ADDENDUM NUMBER: Addendum - One

PROJECT TITLE: County Correctional Facility South

HOC Dormitory Roof Replacement and Repair

PROJECT NUMBER: J063-14432

ROOF CORE SAMPLE REPORT

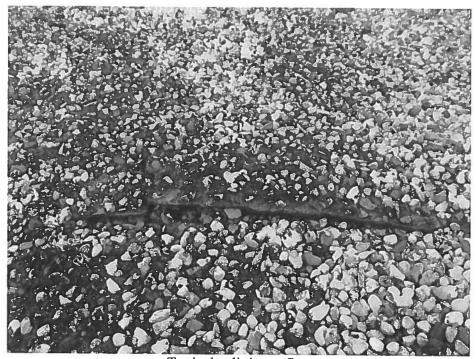
We inspected the two roof areas noted on the drawing below. We found open splits on both roof sections. In our opinion these roofs area prematurely failing due to installer error. We performed a core sample at the drain on both roof areas. Our cores revealed .25" of built up roofing, 3" of light weight concrete insulation over a concrete deck.
